802.3dj D3.1

Comment Resolution

Optical Topics

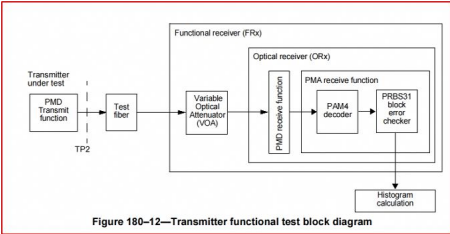
This says "the best estimate of the actual MPI and DGD penalties of the test fiber", yet the fibre alone doesn't make much MPI. The reflections between transmitter and connectors, and receiver and connectors, are more important. It is not clear which reflections are taken as baseline and which are attributed to the fibre, particularly as both transmitter and receiver reflectances are not necessarily at the spec limits. MPI varies with polarisation yet there is no polarisation control in Figure 180-12.

If the TFT section is kept;
if MPI penalty variations are important, explain how the MPI penalty is to be estimated and add polarisation control. If MPI penalty variations are not so important or not feasible to estimate with confidence, use a fixed allocation

Figure 180–9—TDECQ conformance test block diagram

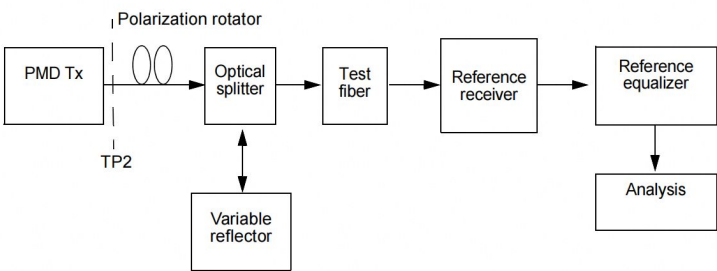
Comment R1-226

Repeating description of polarization.

The optical splitter and variable reflector are adjusted so that each transmitter is tested with the optical return loss specified in Table 180–7. The state of polarization of the back reflection is adjusted to create the greatest RIN. Each optical lane is tested with the optical channel described in 180.9.6.2.

The channel provides back reflection with return loss specified in Table 180–15. The state of polarization of the back reflection is adjusted to create the greatest RIN.
